ZONING BOARD OF APPEALS

TUESDAY, JULY 23, 2019 @ 12:00 PM

Consider a Request by Senergy Builders, LLC for a Variance to Reduce the Required First Floor Height from 15 feet to 12 feet 4 inches Located at 130 North 4th Street.

The Confluence

DATE: 01/14/2019 SHEET NO:

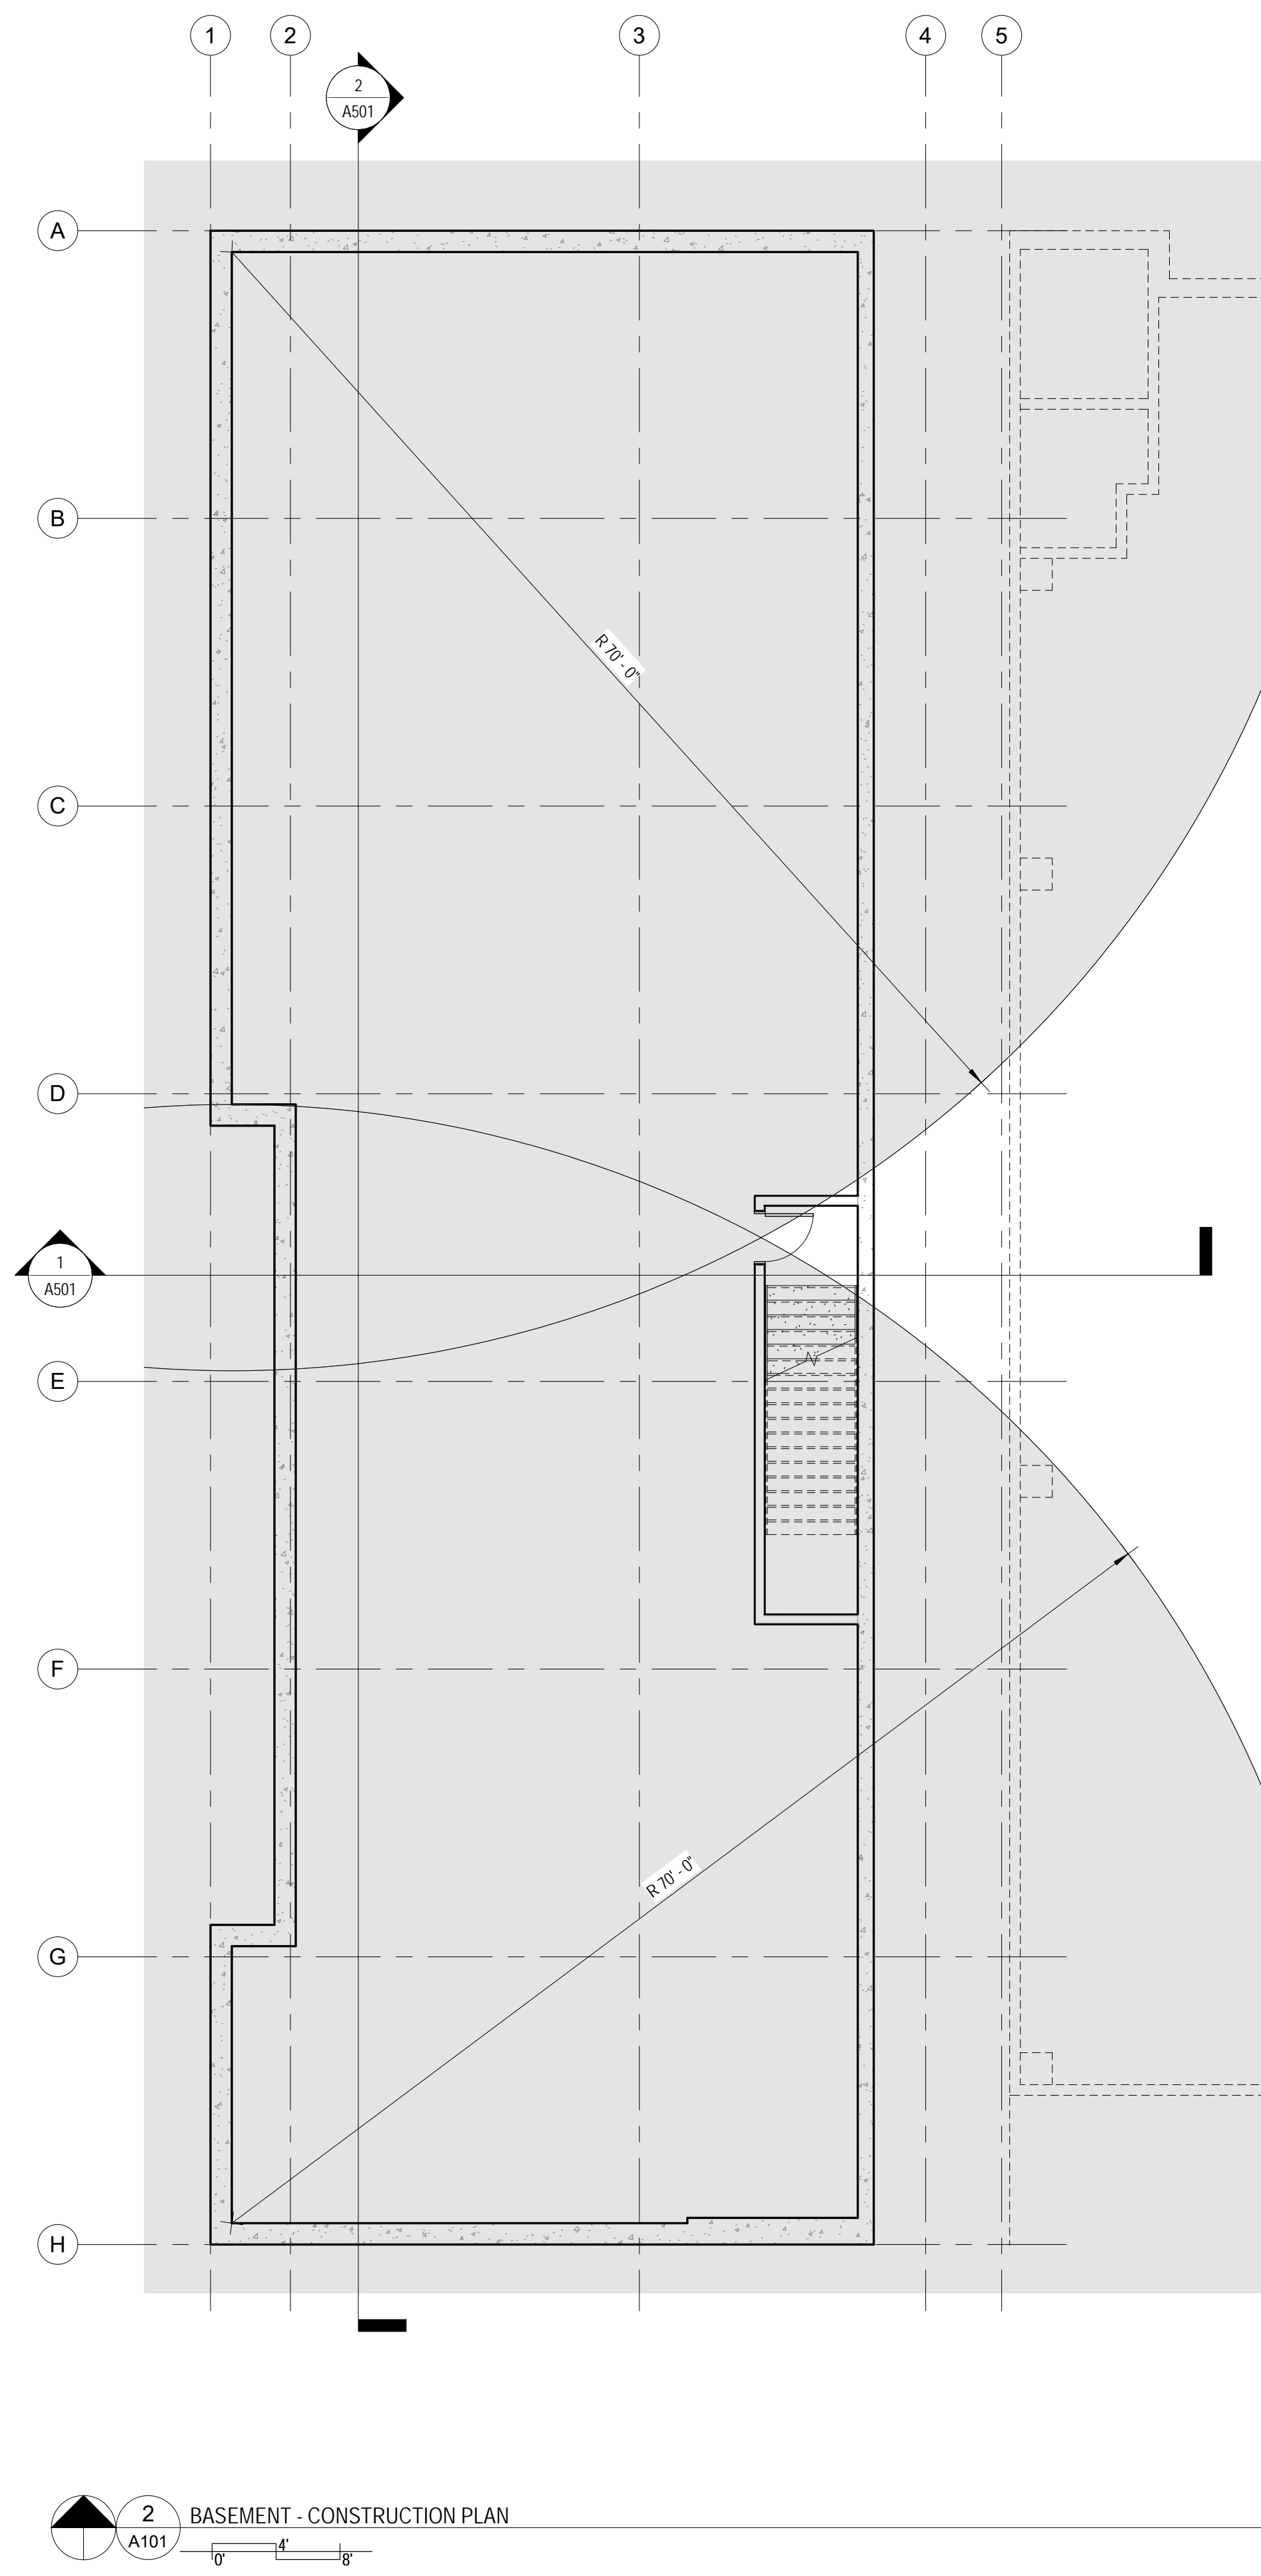
Based on the General Project Report, the Applicant has stated that the hardship is the construction of the parking garage under a different Zoning and Development Code and Building Code from that currently being used. In addition, the Applicant is proposing to match the floor levels of the adjacent parking garage and provide for direct access from the existing elevator in the garage from each of the floors in the proposed building. However, the building can certainly be constructed such that it meets the 15-foot first floor height requirement and utilize the parking garage, just not physically connect to the elevator on each floor. As such, there is no hardship and the

need for the variance is self-inflicted by the applicant's design that has been completed without regard to the Code standards.

The literal interpretation of the Code that includes the requirement of a 15-foot first floor height does not deprive the applicant of rights commonly enjoyed by other properties in the B-2 zone district. The subject property may still enjoy development rights for the scale and type of project proposed without the variance. Staff concludes that this criterion has not been met.

The request is to vary the first floor to a buildable height of 12 feet 4 inches in order to match the access points on the parking garage on each level is a variance of 2 feet 8 inches. This is difference needed to align the first floor height with the parking garage elevator openings and thus is the minimum necessary to make possible the use of this proposed structure. Staff therefore, finds this criterion has been met.

The literal interpretation is that the first floor be 15 feet in height. This is likely due to the desired appearance of having an architectural form that follows the perceived function of downtown in providing spaces to commercial businesses. While this is agreeably so desirable, many of the existing downtown buildings do not meet this criteria. The applicant is seeking to match the RAPP first floor height of 12 feet 4 inches as was intended in the design of RAPP.

The architect has brought the glass line up to the ceiling height and then pushed up each of the steel canopy's an additional 2 feet in order to give the appearance of compliance while achieving the desired architectural standard. See architectural drawing sheet A201. It was the intent of the City and the DDA to build building on each of the RAPP Endcaps and connect the two structures to the parking garage and; to share the use of the two elevators. A 15 foot first floor height makes this unworkable.

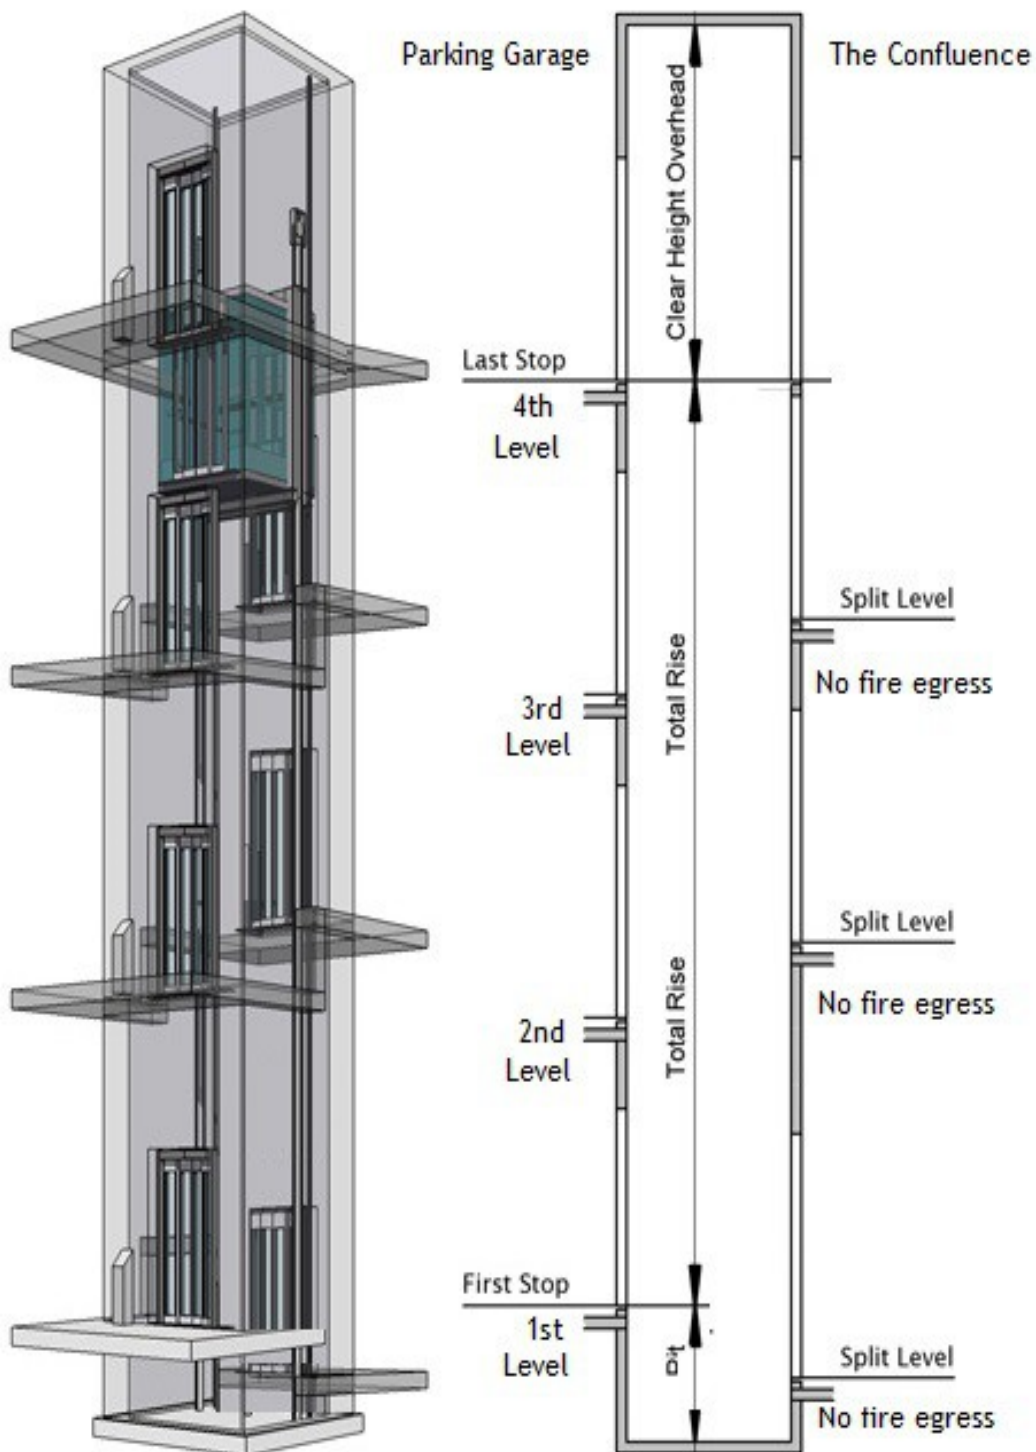
The request is to vary the first floor to a buildable height of 12 feet 4 inches in order to match the RAPP on each level. This will accommodate parking for residents of The Confluence while minimizing wear and tear on the elevator. Increased Fire, life, & safety concerns would also be minimized by creating 4 additional egress points, allowing another entrance and exit at each of the 4 floors.

If the first floor is required to be 15 feet, the 4 additional egress points, one more on each level, would be lost due to the nearly 3 feet offset between the floor of The Confluence and the RAPP. The loss of these 4 safety egress points makes the project much less desirable, much less safe.
